**Ref:** SSD-78493518

**RE: SUBMISSION TO SSD-78493518 FOR RESIDENTIAL FLAT BUILDING WITH INFILL AFFORDABLE HOUSING AT 2-8 HIGHGATE ROAD, LINDFIELD**

### Ku-ring-gai Council's objection to SSD-78493518 at 2-8 Highgate Road, Lindfield

Figure 1: Council's proposed HOB map: 29m

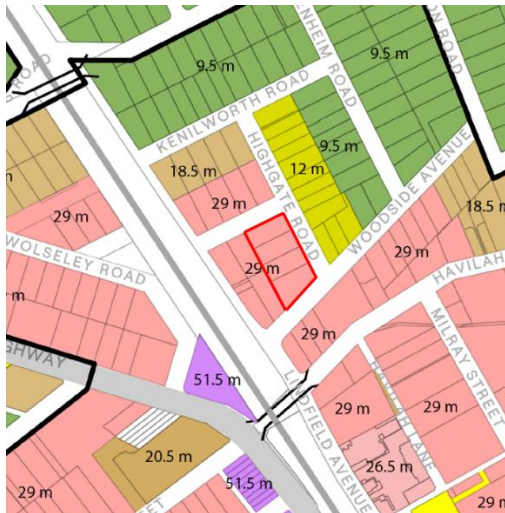
In response to the NSW TOD planning policy, Council has developed a preferred scenario for four railway precincts at Gordon, Killara, Roseville and Lindfield. The exhibited preferred TOD scenario proposes the following height of building (HOB) and FSR development standards under the *Ku-ring-gai Council Local Environmental Plan 2015* (the subject site is outlined in red):

Council's proposed HOB and FSR KLEP amendments would provide for a development that is less bulky, provides an appropriate interface with the land to the north-east and allows for suitable landscaping. Council's proposed FSR would also enable a development on the site which provides a high level of residential amenity compared to the subject SSD proposal.

The proposed building is excessive in height, bulk and scale. The land on the opposite side of Highgate Road to the north-east is currently zoned R2 and contains 1-2 storey detached dwelling houses. The land on the opposite side of Highgate Road is proposed to be rezoned to R4 with a HOB control of 12m and an FSR of 0.85:1 (**Figure 1**) under Council's alternative TOD scenario.

**Figure 3: Applicant's GFA Calculations**

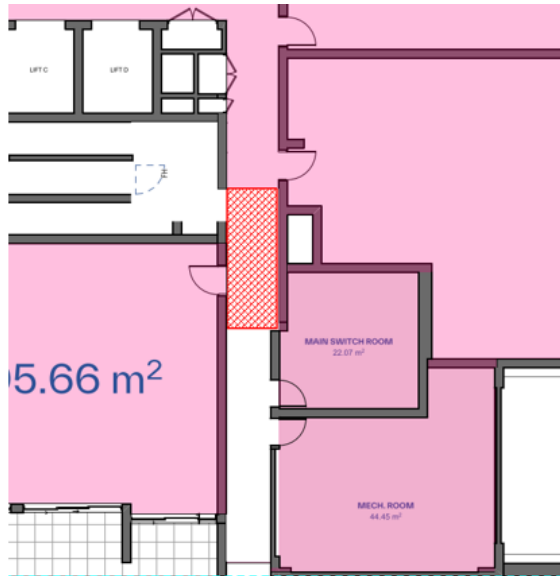
The Applicant has not included the entire corridor on the ground floor adjacent to the main switch room in the GFA, as indicated in red in the diagrams below:

The consent authority needs to carefully review the Applicant's GFA calculations to ensure compliance with the maximum permitted FSR.

**Figure 5: Centre apartments with non-compliant depth (repeated layout from ground level to Level 7)**

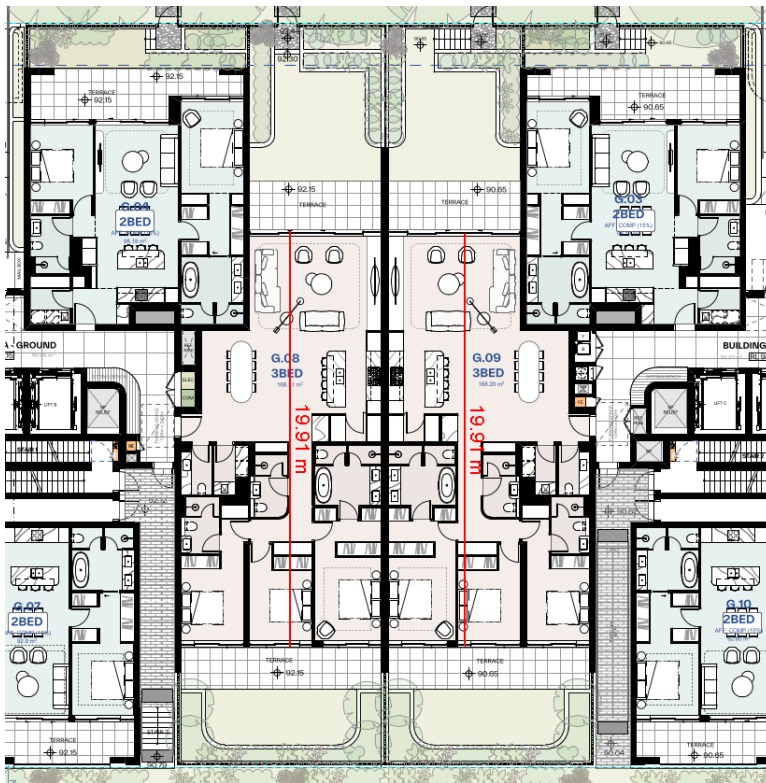
Furthermore, the design of the building results in the apartments in the middle of the building having a depth of approximately 19.91m which exceeds the maximum apartment depth of 12-18m recommended in Part 2E of the Apartment Design Guide:

To reduce the bulk and scale of the development and improve the interface with Highgate Road, it is recommended that the proposal is amended in the following manner:

- Reduce the FSR to an amount which enables a fully ADG compliant development while ensuring a building with an acceptable bulk having regard to the predominantly lower density residential context. This could be achieved by providing two separated residential flat buildings on the site (above a consolidated basement) to provide a break in the building mass along Highgate Road while giving greater consideration to future amenity on the adjoining SSD development to the west of the site. This would also assist in improving solar access and natural cross ventilation (see discussion below).

**Figure 6: Council's mark-up of Applicant's natural cross ventilation compliance diagrams.**

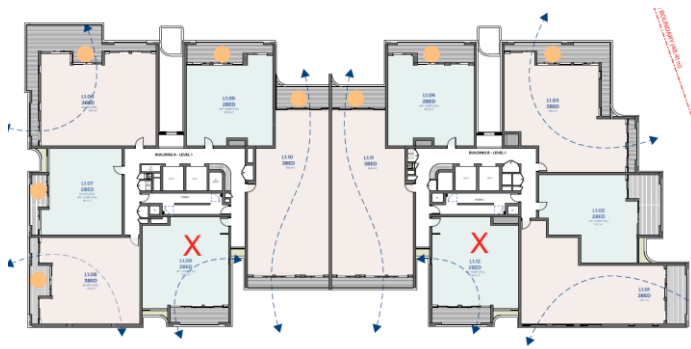
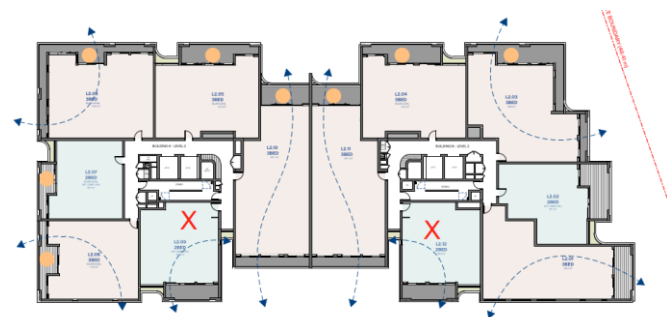
Part 4B of the ADG requires at least 60% of all apartments to be naturally cross ventilated. According to the Applicant's calculations, 62% of the apartments are naturally cross ventilated. However, the Applicant's calculations are incorrect. Apartments that rely on a 'notch' or 'building indentation' cannot be considered as naturally cross ventilated in accordance with the ADG design guidance. 49 (58.2%) of the 84 total apartments are naturally cross ventilated which does not comply with the ADG.

The following apartments marked with a red cross on the Applicant's natural cross ventilation diagrams are not naturally cross ventilated:

**Figure 7: Proposed building separation at the 9<sup>th</sup> storey of the two buildings proposed under the subject SSD and the adjoining site (SSD-79261463)**

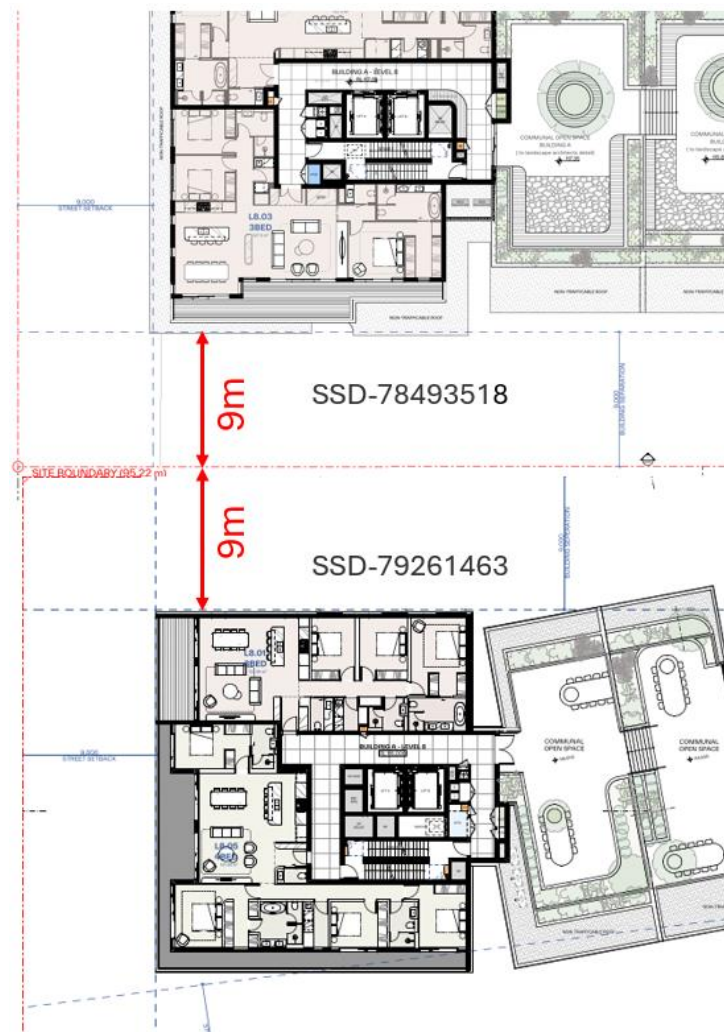
The top storey (9<sup>th</sup> storey) is required to be setback 12m from the south-west rear boundary in accordance with Part 3F of the ADG. The balcony to the top storey (apartment L8.03) is setback only marginally greater than the 9m from the rear boundary which does not comply with the ADG.

This is further exacerbated by the non-compliant 9m setback of the 9<sup>th</sup> storey proposed under the adjacent SSD application, as shown in **Figure 7**. A building separation of 24m at the 9<sup>th</sup> storey is required between the two buildings under Part 2F and Part 3F of the ADG. The two buildings are located only 18m apart which is a significant non-compliance.
